City of Glendale
Community Development Department
Design Review Staff Report – Multi-Family

Meeting/Decision Date: October 11, 2021	Address: 3419 Montrose Avenue
Review Authority: <input type="checkbox"/> DRB <input checked="" type="checkbox"/> ADR <input type="checkbox"/> HPC <input type="checkbox"/> CC	APN: 5607-004-032
Case Number: PDR2106786	Applicant: Helbert Moradian
Prepared By: Danny Manasserian, Planning Associate	Owner: Arbita Nersesian

The applicant is proposing to construct additions at the front and rear of the existing house, build a new two-story residential unit and garages behind the house, and demolish the existing garage. The property is located in the R-3050 (Moderate Density Residential) zone.

**UNIT
ELEVATIONS**

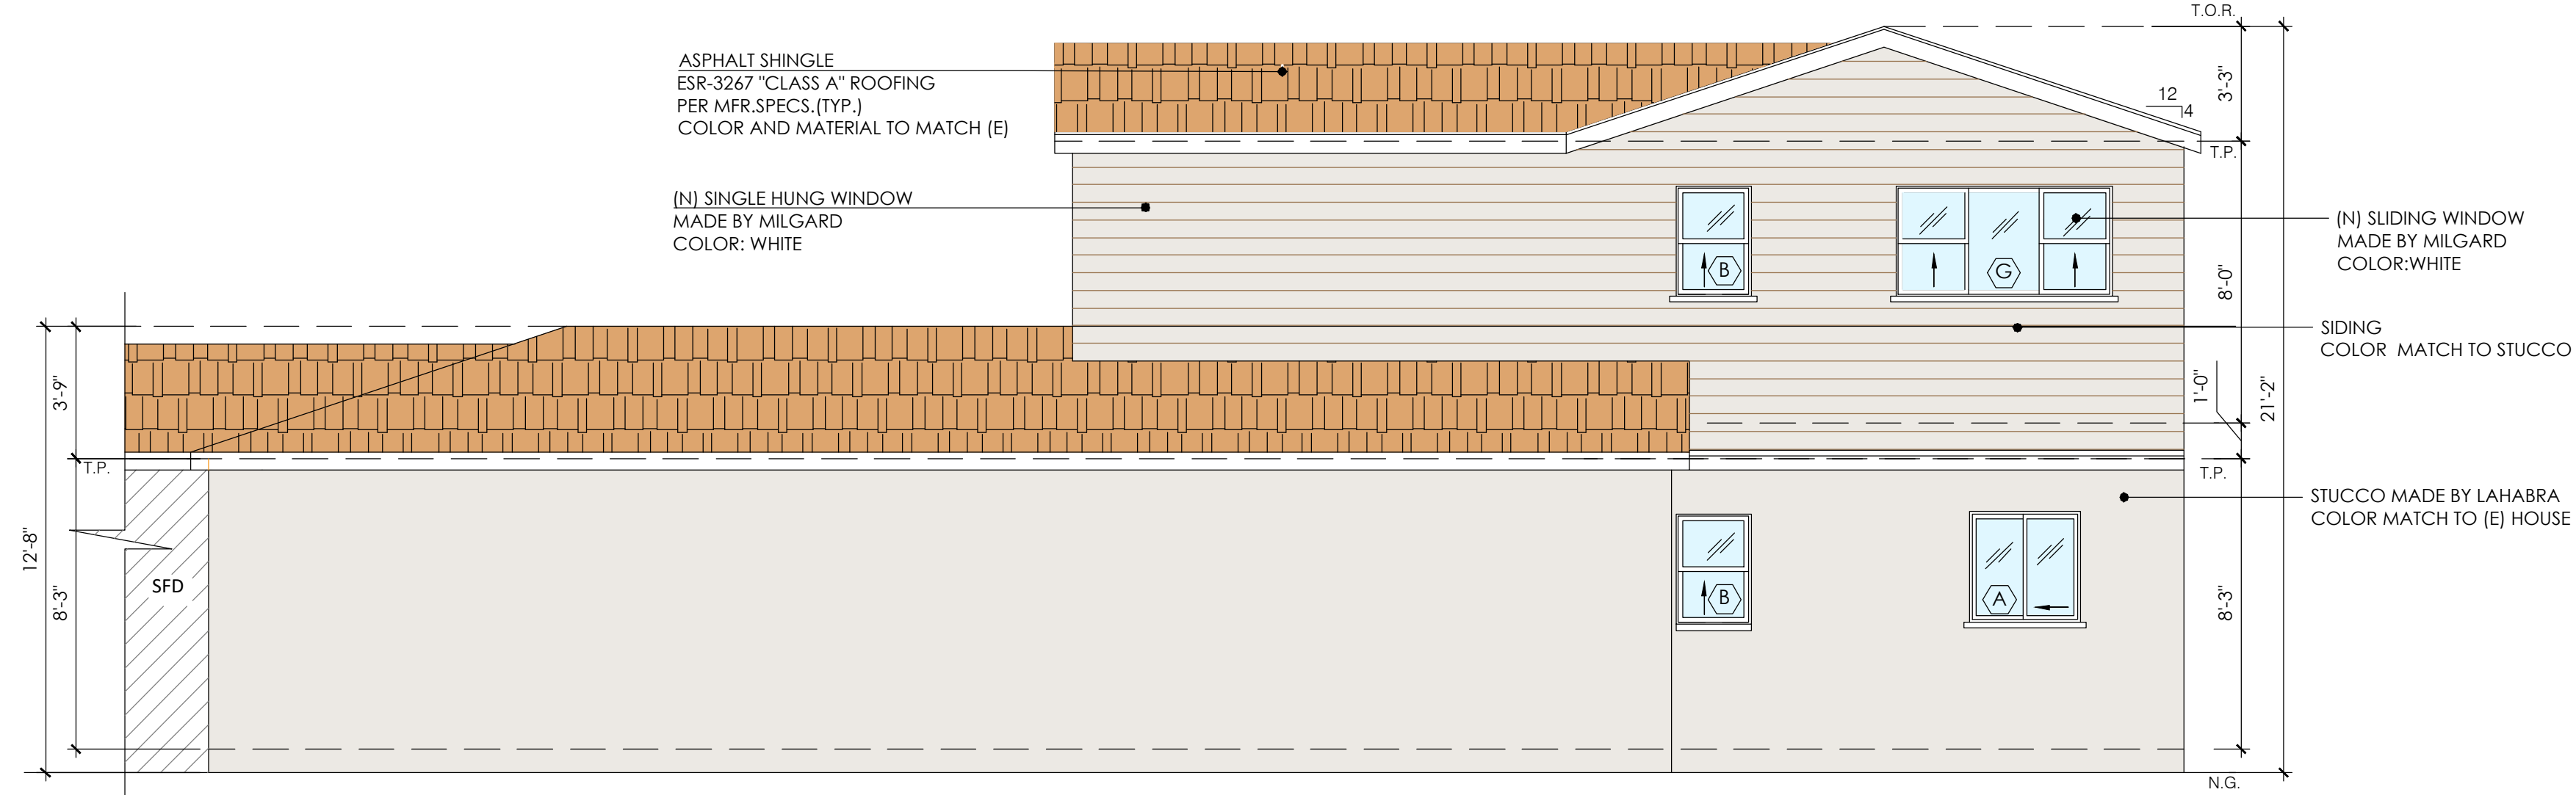
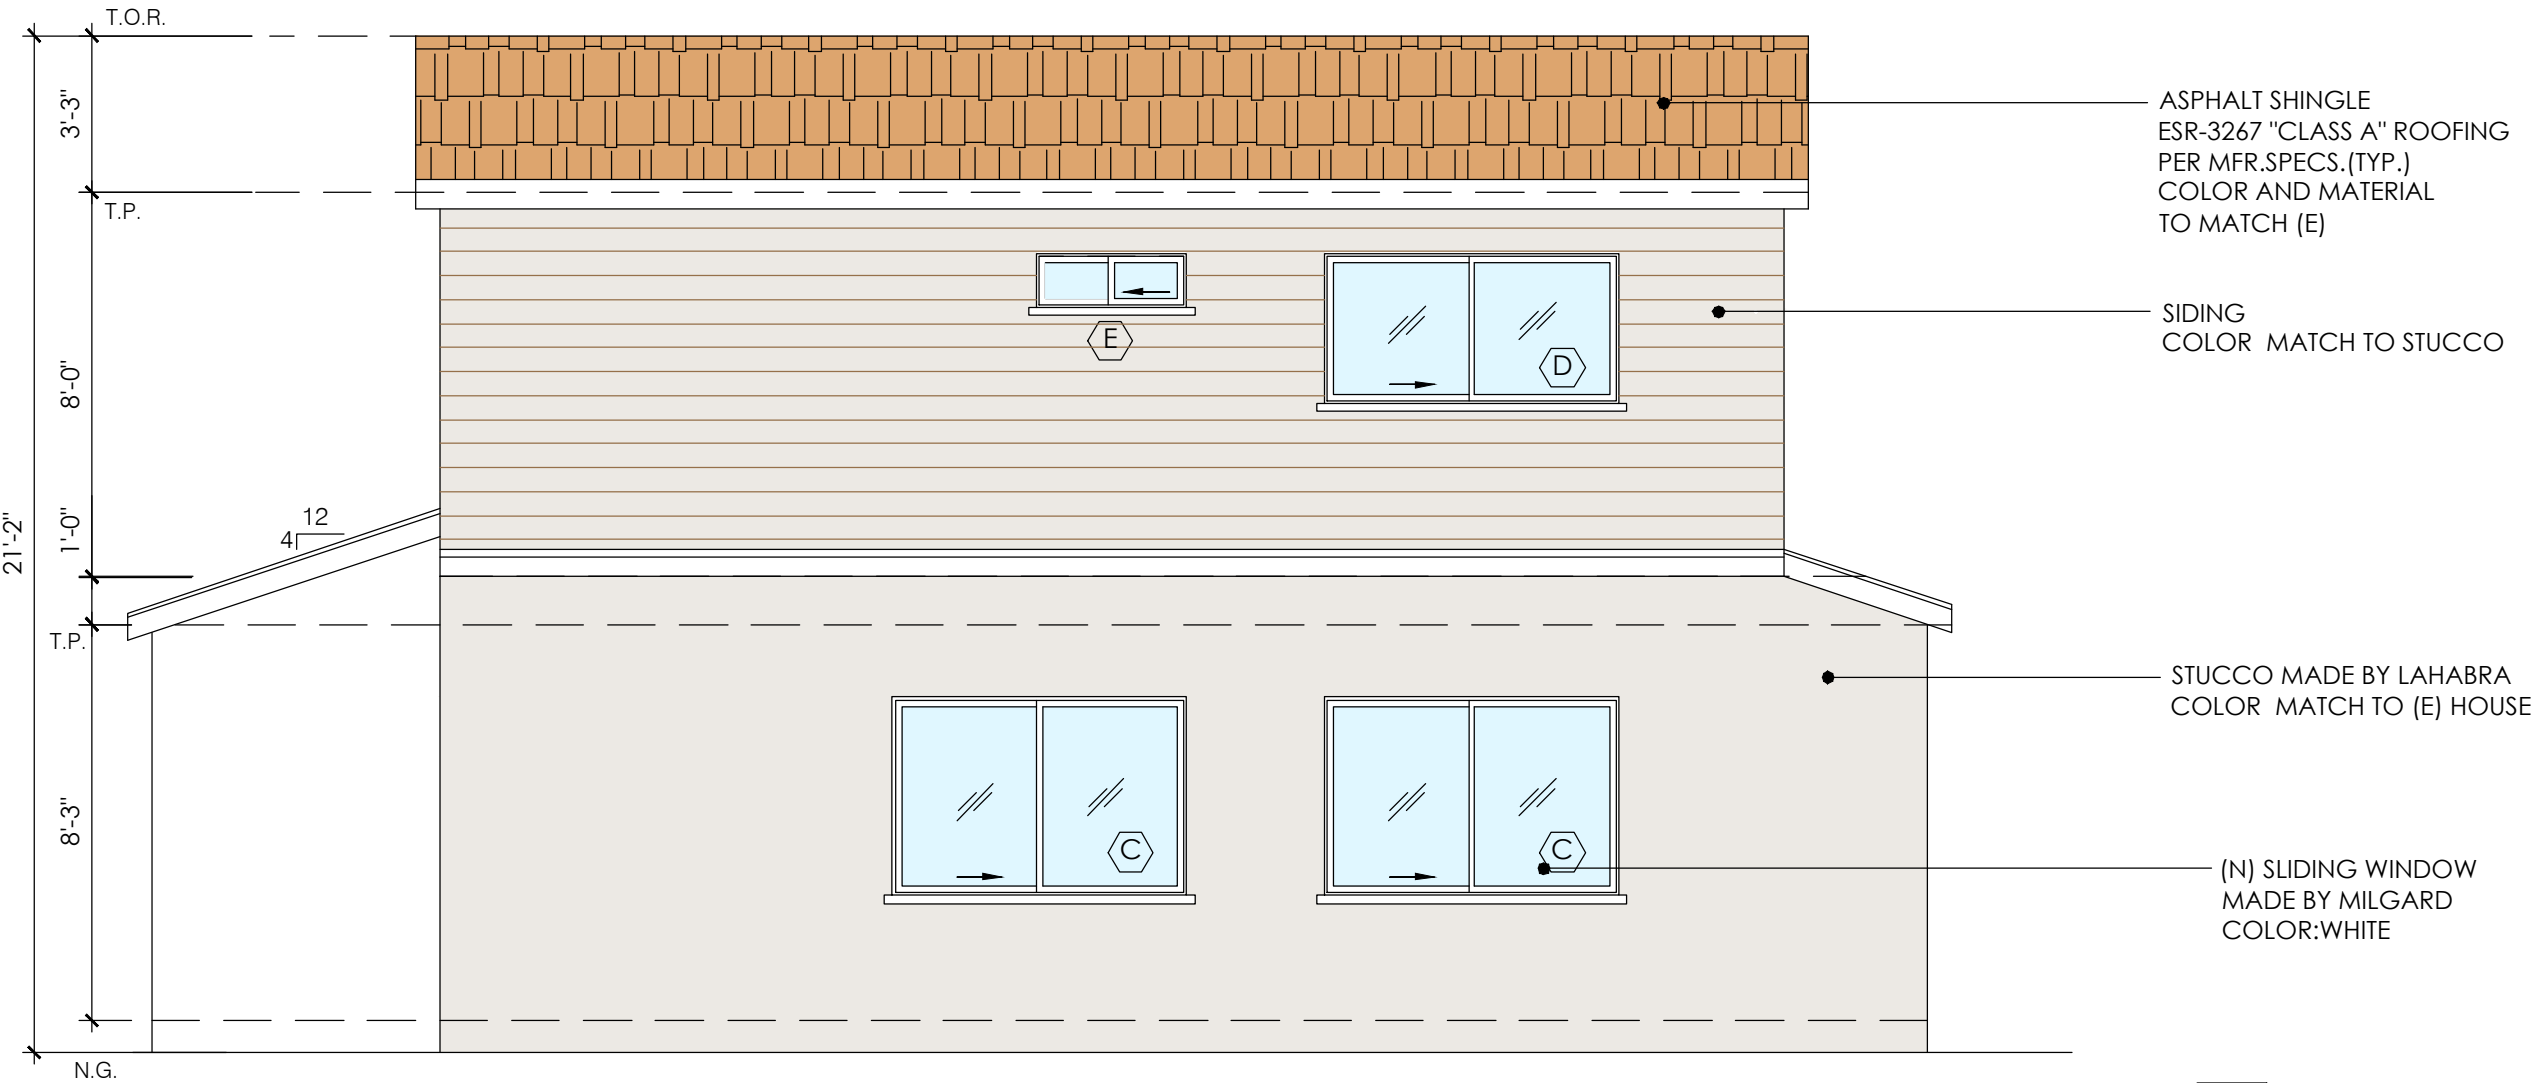
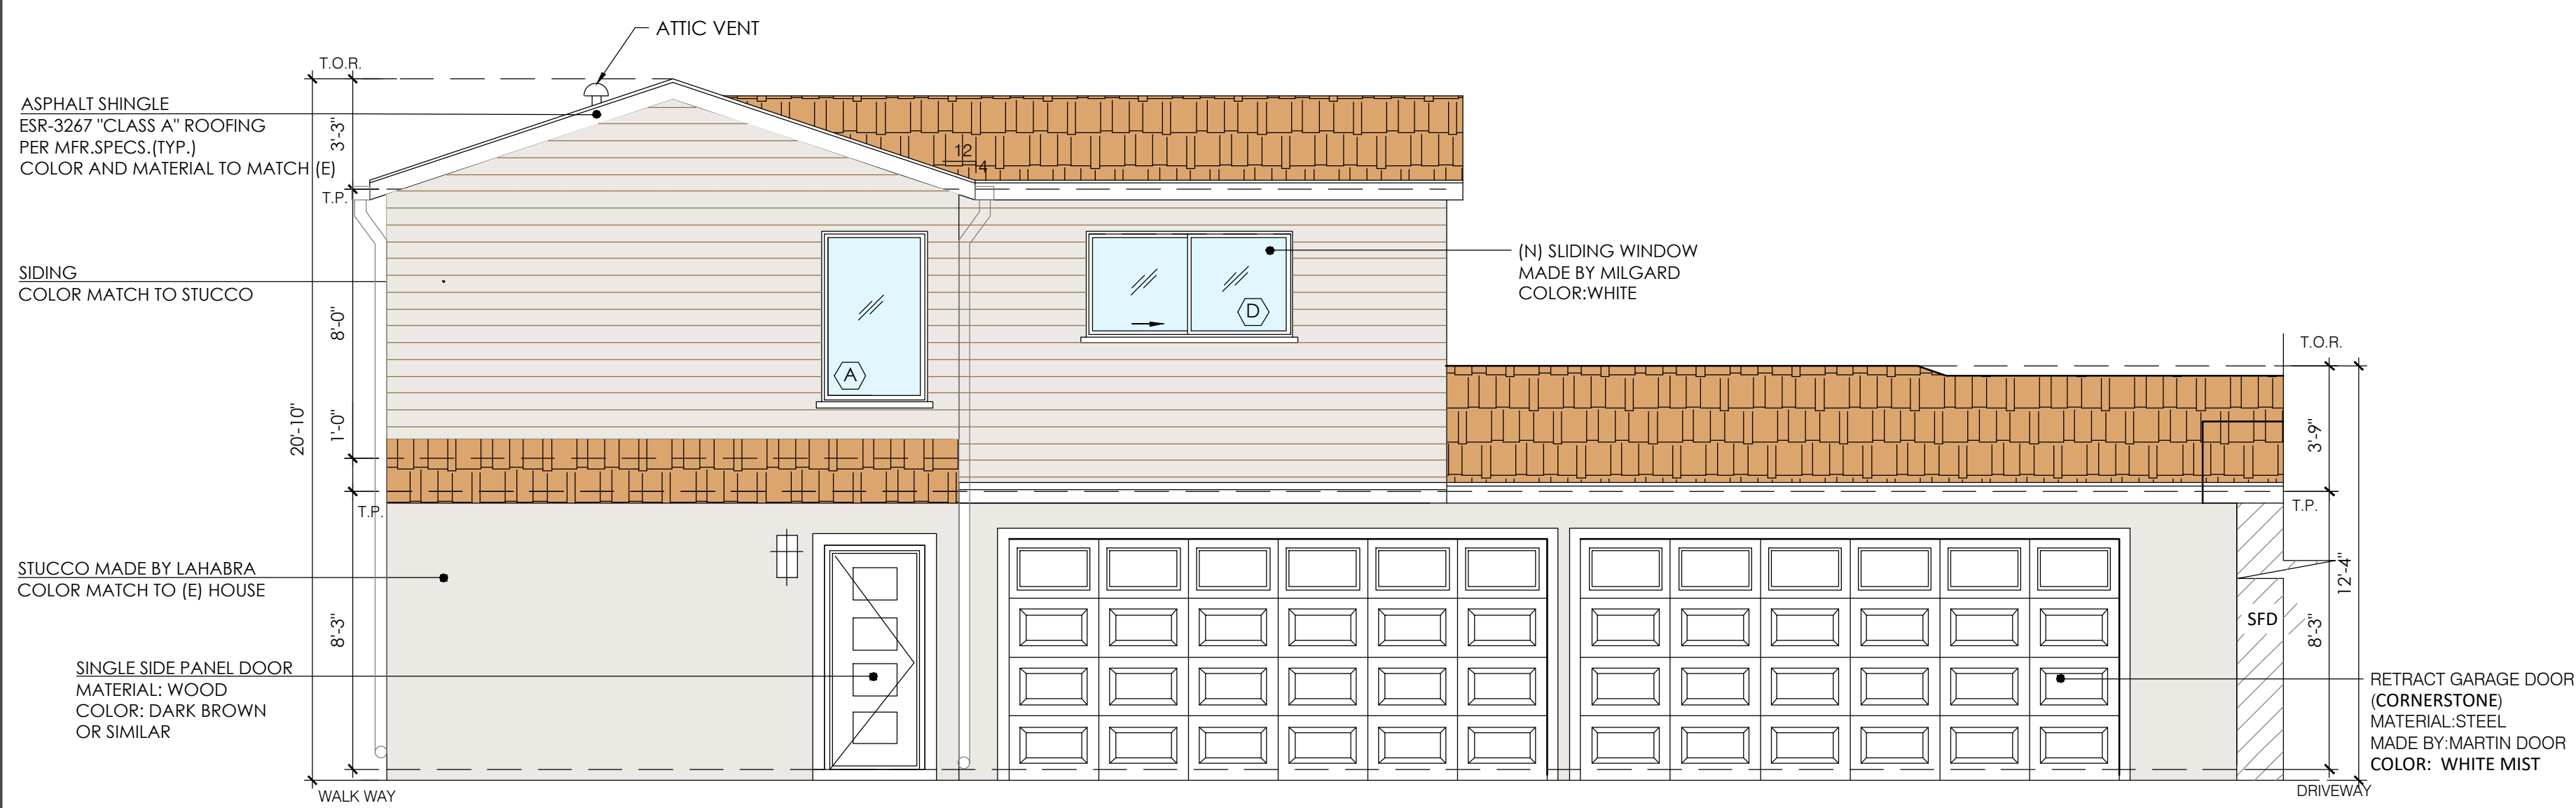
The design will be enhanced if the siding color is somewhat darker, rather than the same as, the color of the walls. A condition to this effect is added.

- The traditional design of the new unit is appropriate to the neighborhood and the existing house.
- The placement of the proposed cement fiber siding on the new unit is appropriate, however, as proposed, the color is the same as the stucco. A condition has been added to choose a somewhat darker color to complement the white stucco.
- All windows will be vinyl, recessed with a wood sill and frame to match the proposed windows on the front house. As proposed, the windows are appropriate to the design and the neighborhood in terms of their operation and overall appearance.
- The roof material includes brown composition shingle, matching the front house.

1. Propose somewhat darker color for cement fiber siding at new unit for staff review.
